rainTree consulting

50 CONDOVER STREET – NORTH BALGOWLAH, NSW
4.55 DESIGN MODIFICATION
ARBORICULTURAL REPORT
Ref No: 4425

Tree 6 (Angophora)

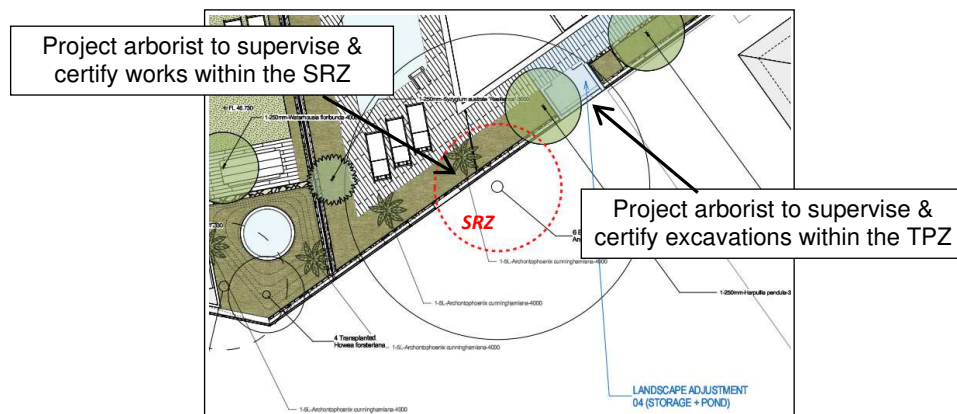
2. Proposed landscape adjustment of Storage & Pond of *Minor* (<10%) TPZ occupancy being outside the SRZ, indicating the impact is likely to be a low-level disturbance within the TPZ. General additional tree management is recommended to consist of:
 - All excavations within the 5.4m radial Tree Protection Zone (TPZ) to be supervised & certified by an appointed site arborist.
 - No excavation or demolition to occur within the SRZ, specific to any boundary retaining wall without direct onsite project arborist supervision & certification.

Tree / Palms 11 & 12 (Cocos Palms)

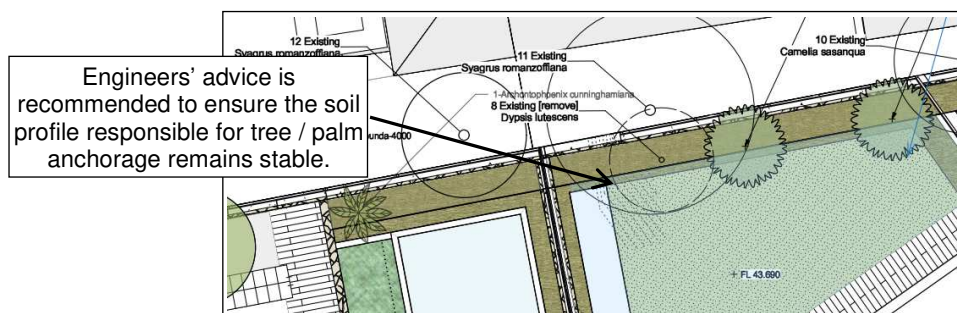
3. Proposed landscape adjustment is within the footprint of original works indicating the management of the neighboring palms remains the same to previous recommendations being specific to:
 - Engineers' advice is required to ensure and certify the soil responsible for tree anchorage remains stable by the proposed excavation cut, and specifically the removal of the rock outcrop within the TPZ of T11.
 - A colour coded Bulk Earthwork (cut & fill) plan should be provided for project arborist assessment.
 - Civil design plans for retaining walls, specifically along or adjacent to the boundary and within tree protection zones should be reviewed for comment by an appointed arborist prior to instalment.

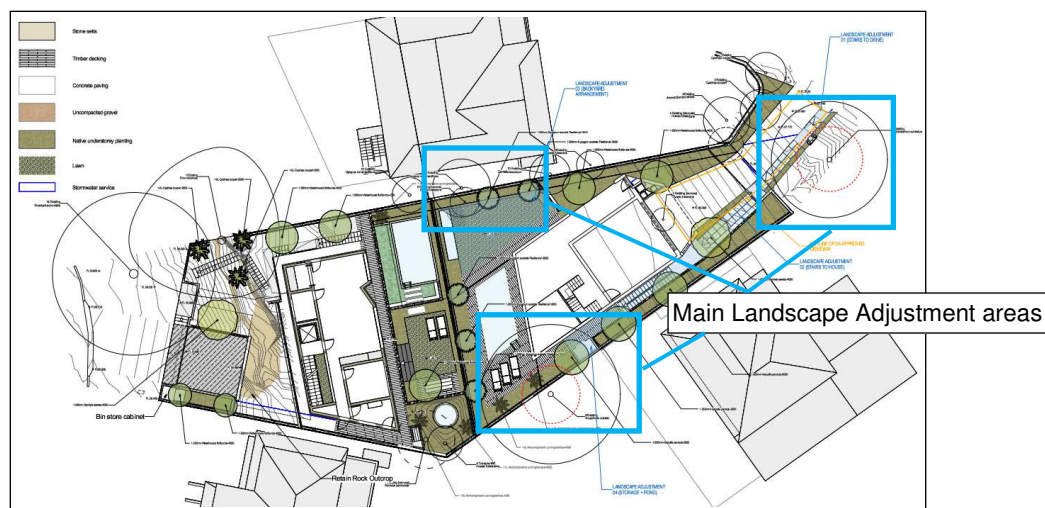
4. The remaining Landscape Adjustment as shown below indicates remaining trees are not altered by the design amendment with all recommendations provided within Raintree Consulting's Arboricultural Impact Assessment (AIA) ref No: 3323 applying for the management of trees.
